PLANNING COMMISSION AGENDA

TO: Planning Commission
THROUGH: Deanna Kuennen, Community & Economic Development Director
FROM: Peter Waldock, AICP Planning Coordinator
MEETING DATE: March 7, 2022
SUBJECT: Applications Submitted by Kwik Trip Inc. Related to Development of a New Convenience Store / Fuel Station and Car Wash at 1955 2nd Avenue NW

TO: Development Review Committee
FROM: Peter Waldock, AICP Planning Coordinator
MEETING DATE: February 22, 2022
SUBJECT: Applications related to Kwik Trip 793 at 1955 2nd St NW

PRELIMINARY PLAT OF:
KWIK TRIP 793

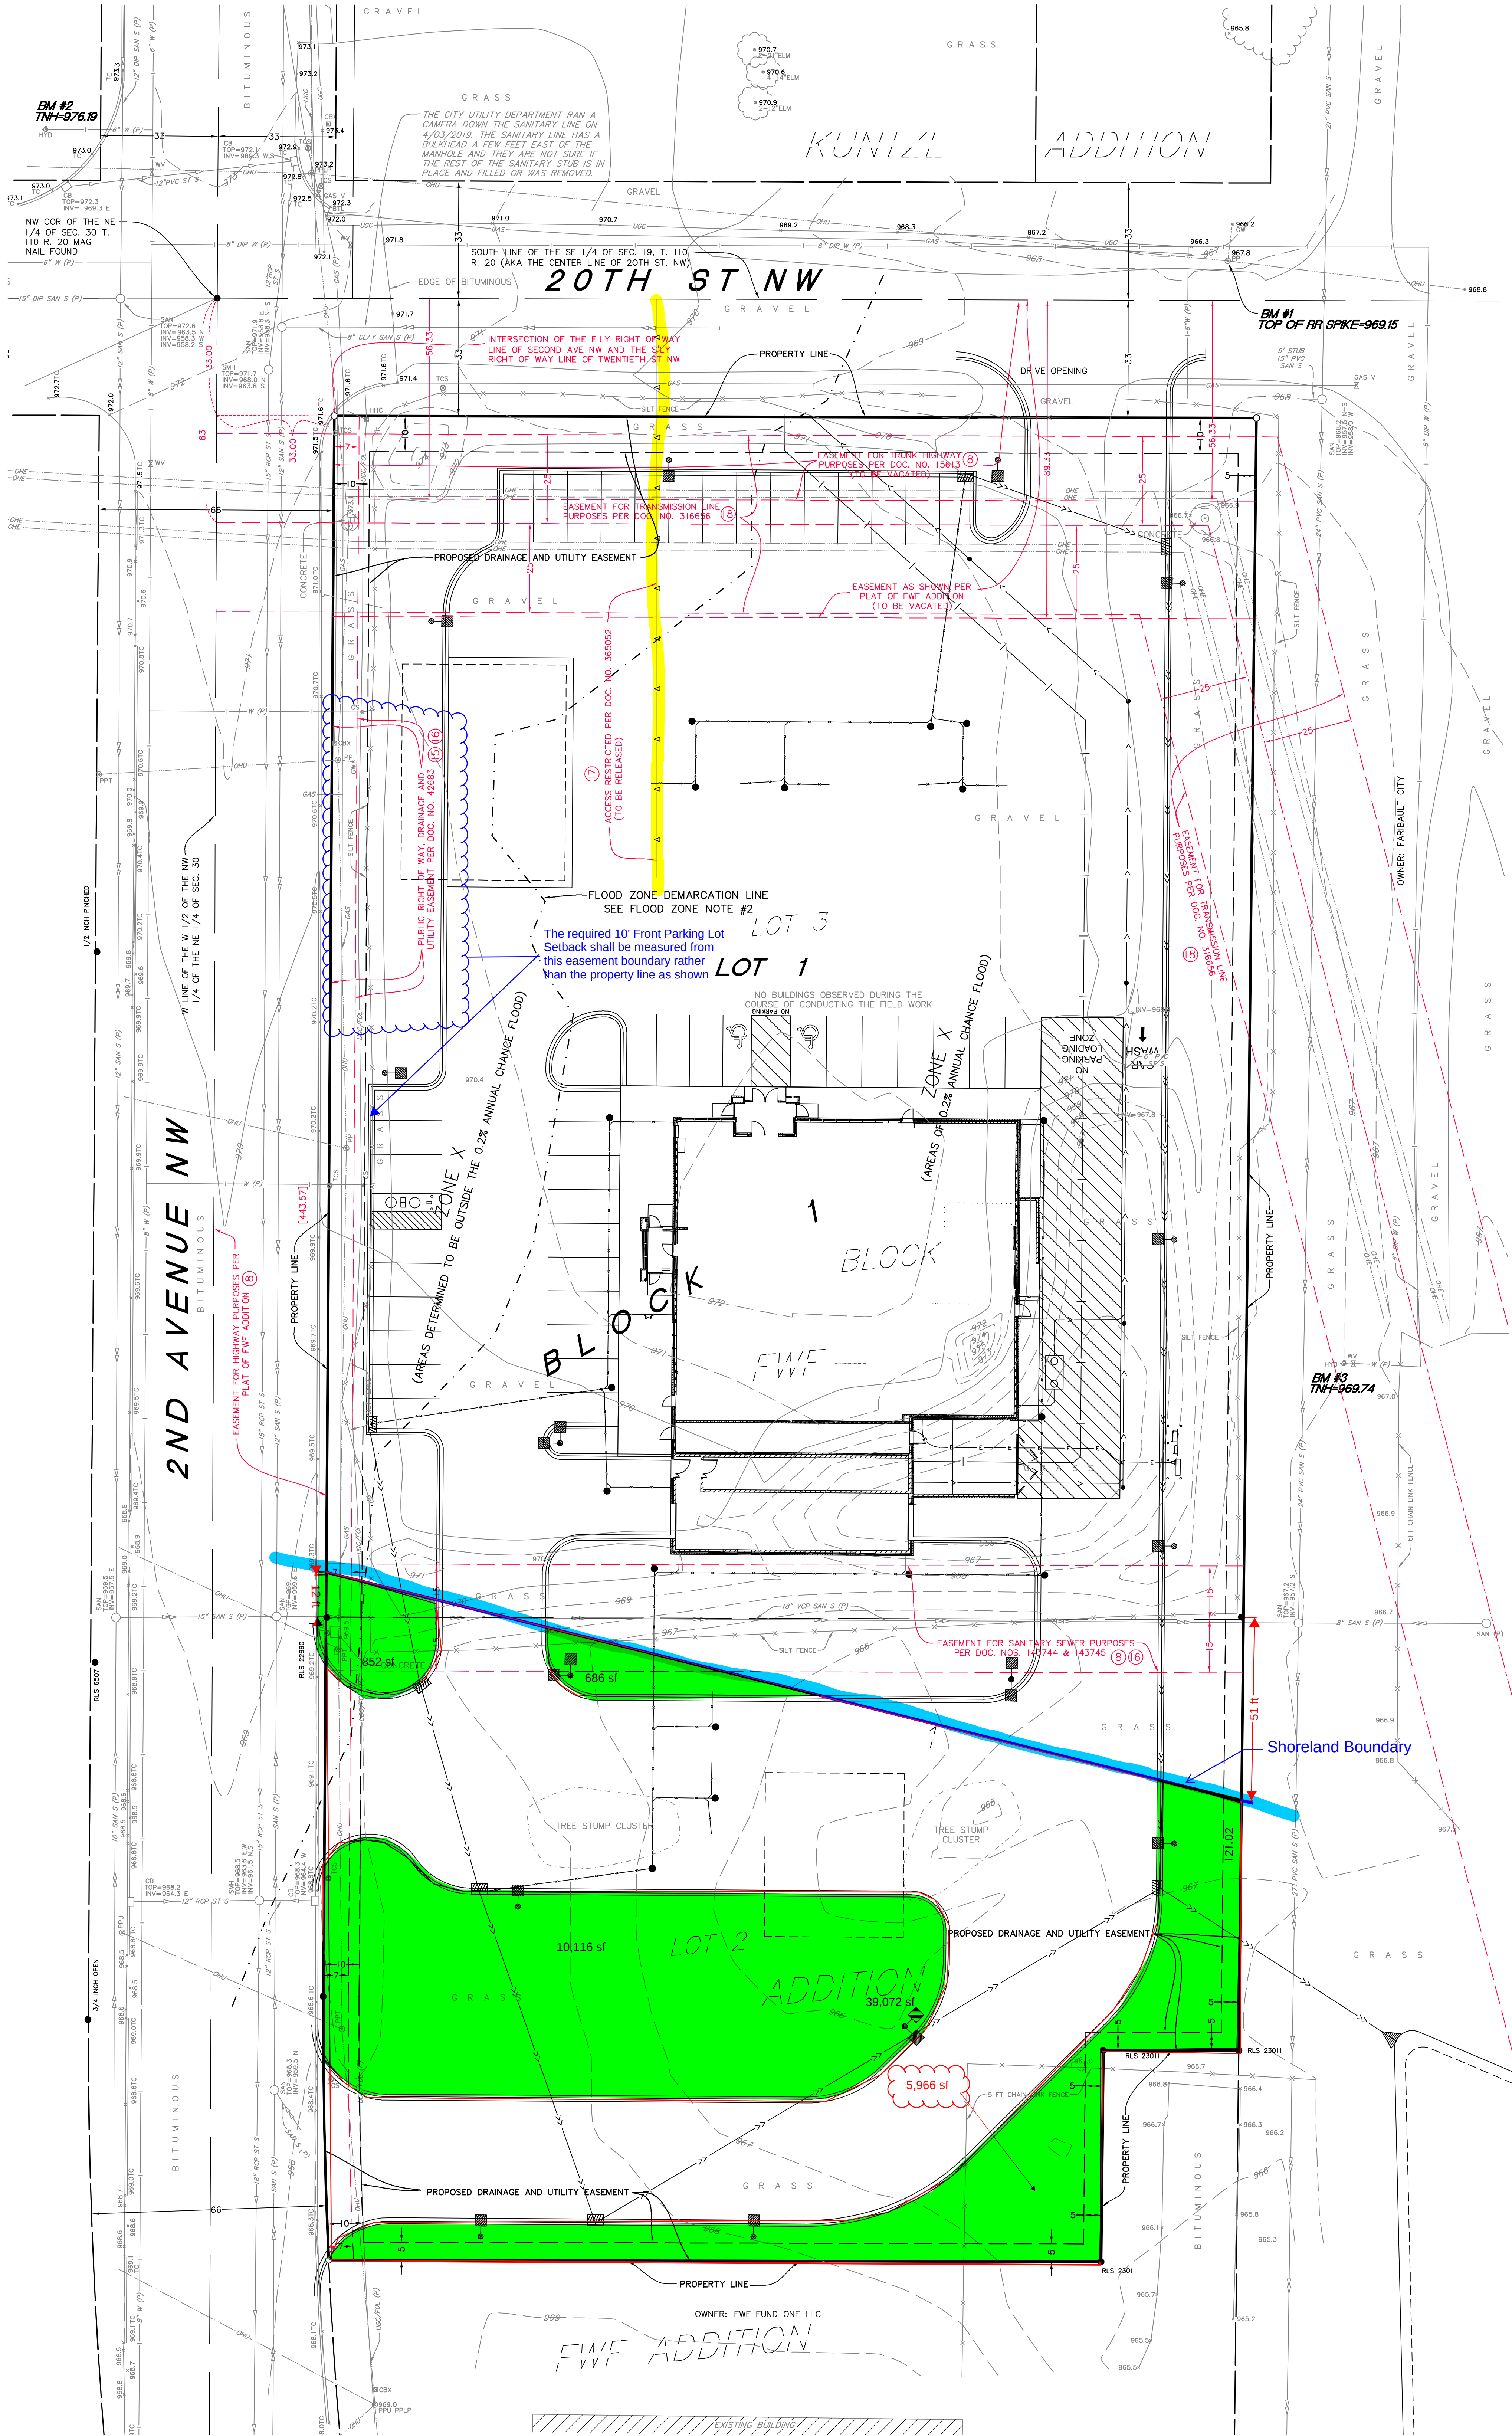
Subdivision Proposal. The subdivision application in this case re-plats lots 2 and 3 of FWF Addition to create one commercial lot. The subdivision will need to dedicate an additional 7 feet of right of way along the west property line that is currently platted as a public right of way and utility easement. This change will not effect setbacks as they are measured from the easement boundary. Parkland Dedication was satisfied for this site with FWF Addition plat approval.

Developer shall revise the final plat to dedicate the existing 7-foot Public Right-of-Way Drainage and Utility easement per Doc 42683 as public right-of-way for 2nd Avenue NW. All setbacks shall be measured from this right-of-way line.

SITE PLAN (LAYOUT)
CONVENIENCE STORE #793
WITH SINGLE BAY CARWASH
& SIDE DIESEL
2ND AVE NW & 20TH ST NW
FAIRBAULT, MINNESOTA

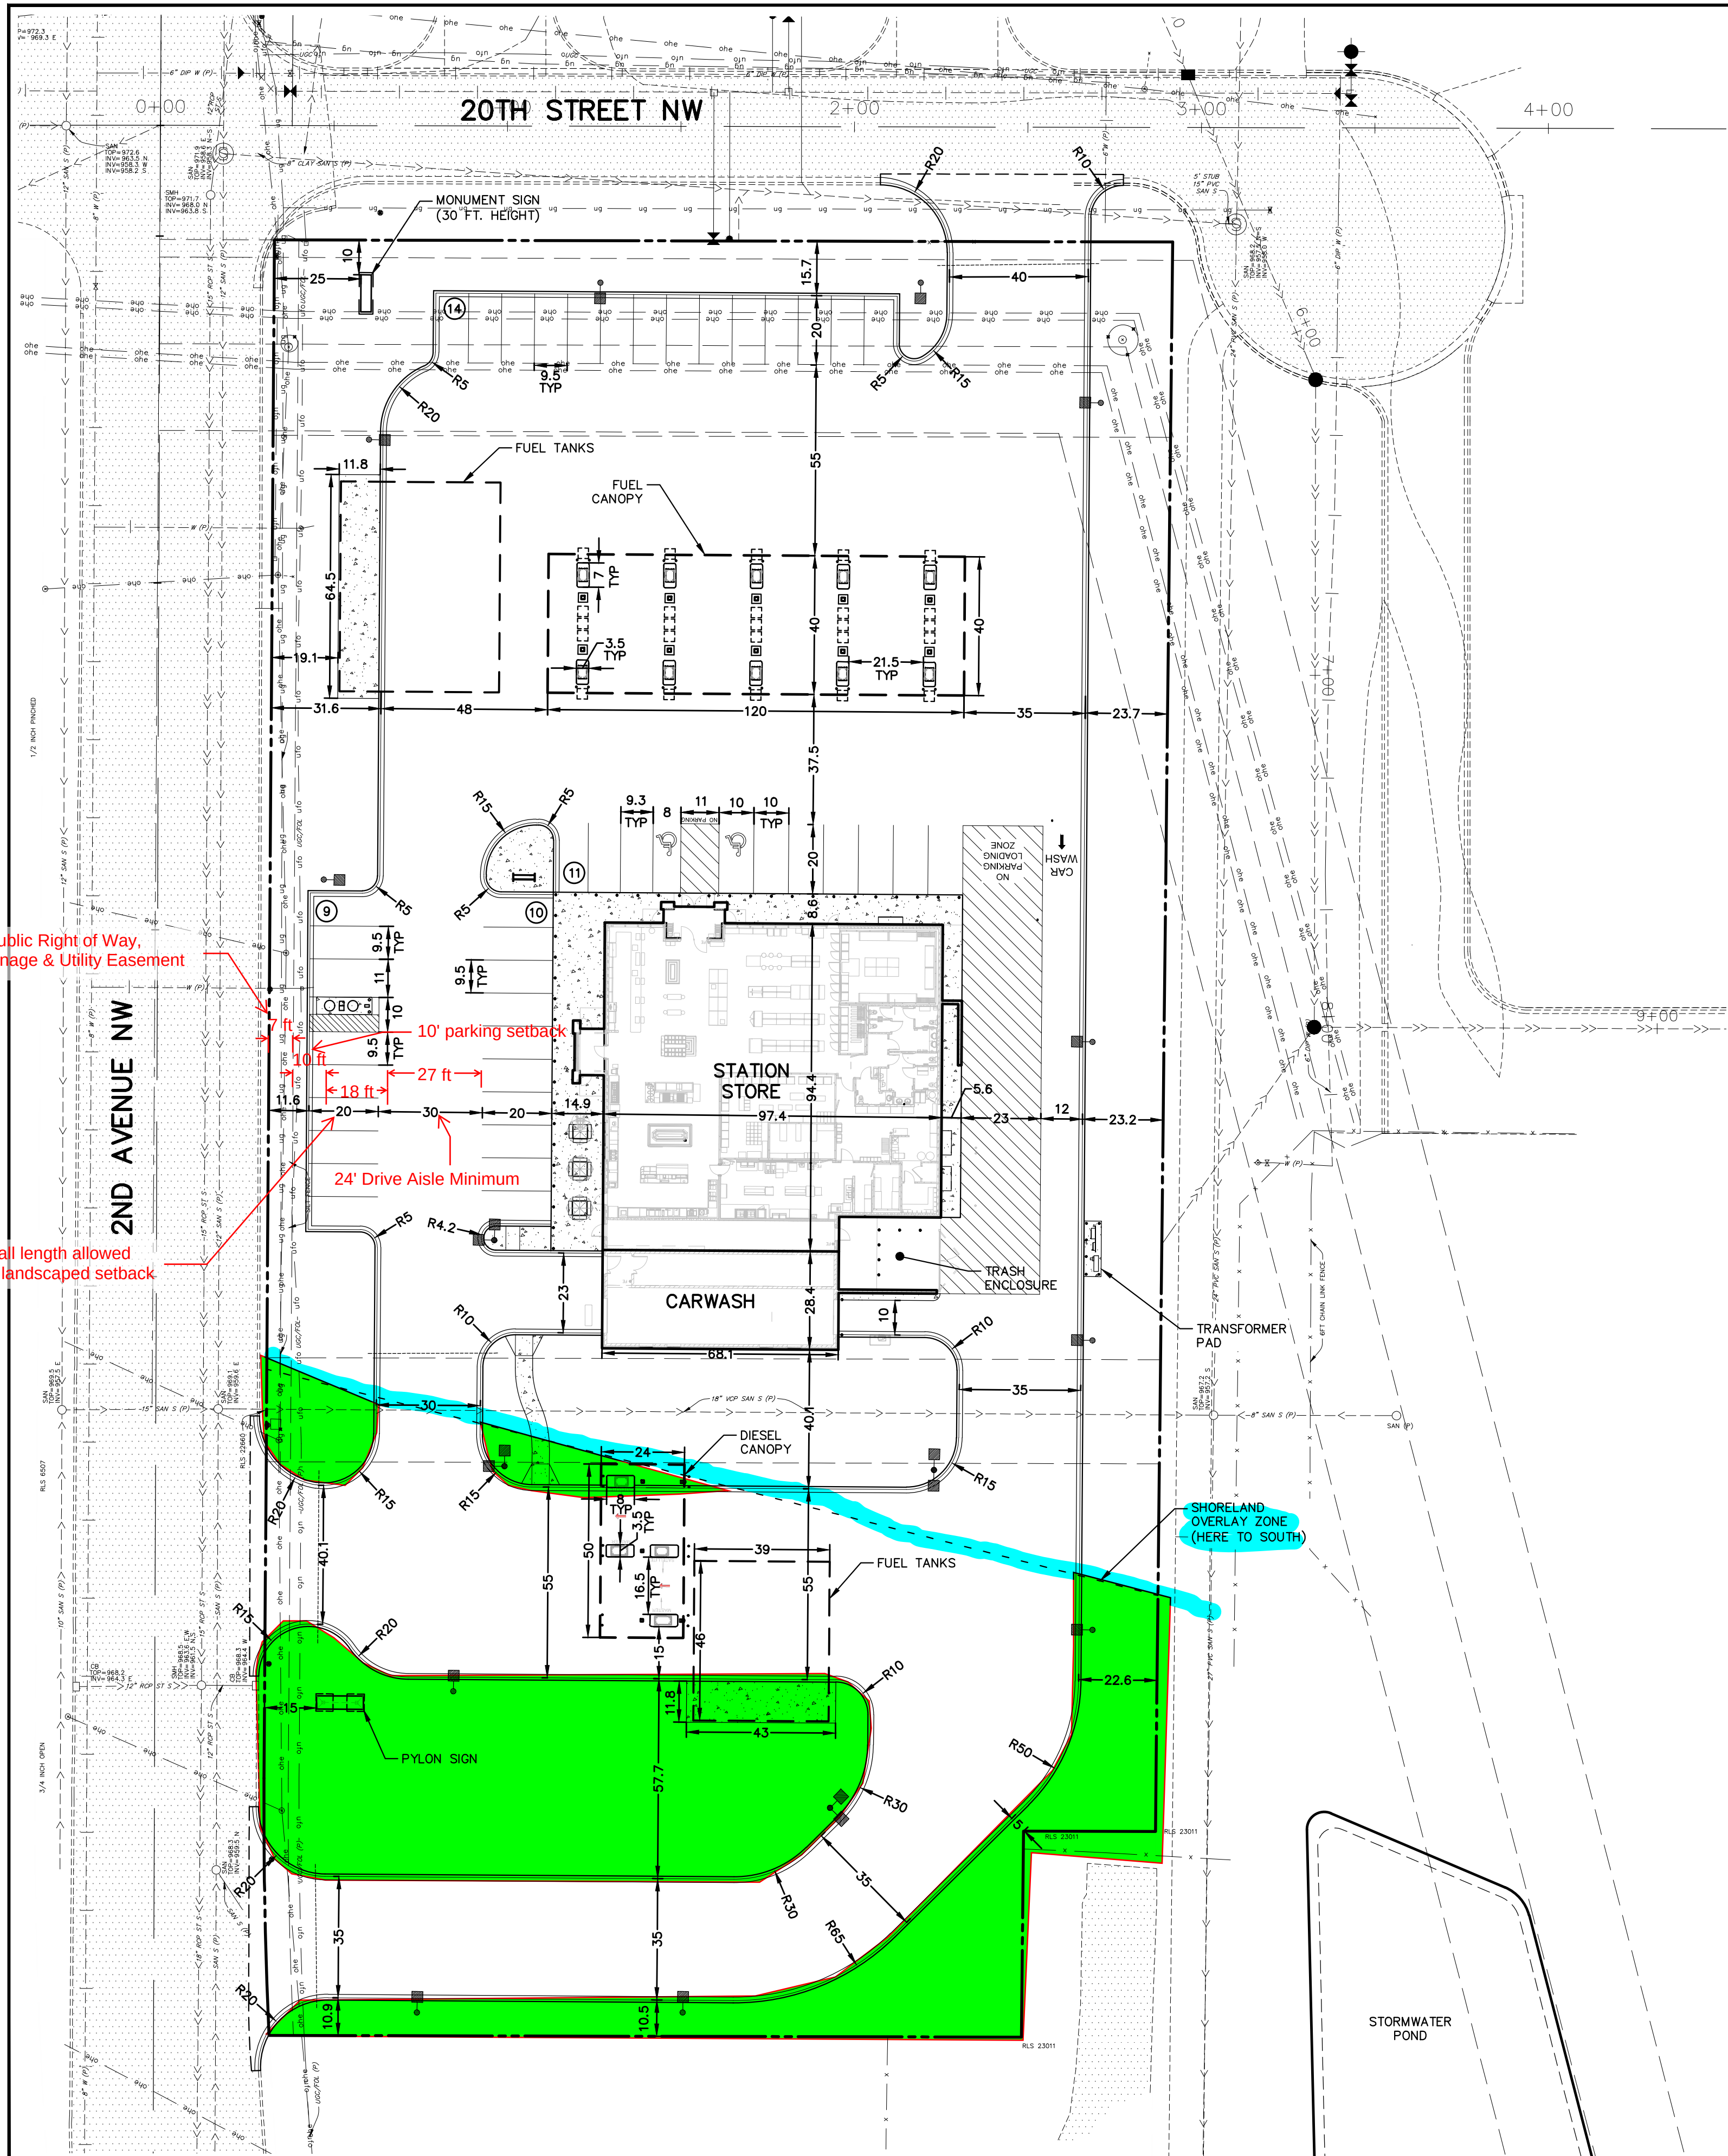
Zoning Requirements. The applicants intend to meet all standards required by the City's Unified Development Ordinances (UDO) without variances. During the site plan review, City staff noted some adjustments are needed to the west curblineline of the parking lot to increase the separation from the 2nd Avenue right of way. This can be done without affecting the onsite parking and vehicle circulation. It will reduce pavement and still meet all ordinance standards.

3. Setbacks are measured from right of way easements. The site plan will need to be adjusted to provide the required 10 foot front setback from this easement for the west parking lot.

- Setback Requirements. The site plan exceeds setback requirements for the building and pump island canopies. Parking lot setback requirements are measured from the property lines and from street right of way boundaries in cases where there is a right of way easement. In this case there is an additional 7' street right of way easement along the west property line for the site. The site plan will need to be amended to provide a 10' front parking setback from the right of way easement along 2nd Avenue. This 7' right of way easement should be dedicated with the final plat for this site.

- Parking Requirements. 1 space / 300 SF of gross floor area is required. With a 9,000 SF building there will need to be a minimum of thirty (30) spaces to meet this requirement. The site plan shows 42 regular spaces with two (2) handicapped spaces. In addition, there are 22 spaces at the pumps. The site plan exceeds minimum standards of the UDO. The parking and driveway areas are paved.

- Curb Cut Width. The UDO limits commercial driveways to thirty-two (32) feet in width. The minimum separation is twenty-five (25) feet between driveway openings and fifty (50) feet from intersections. The City Engineer has authority to approve curb cuts of up to fifty (50) in width where necessary. In this case the curb cut width shown on the plans ranges from thirty-five (35) feet to about forty (40) feet wide. The two main entrances have a forty (40) width.
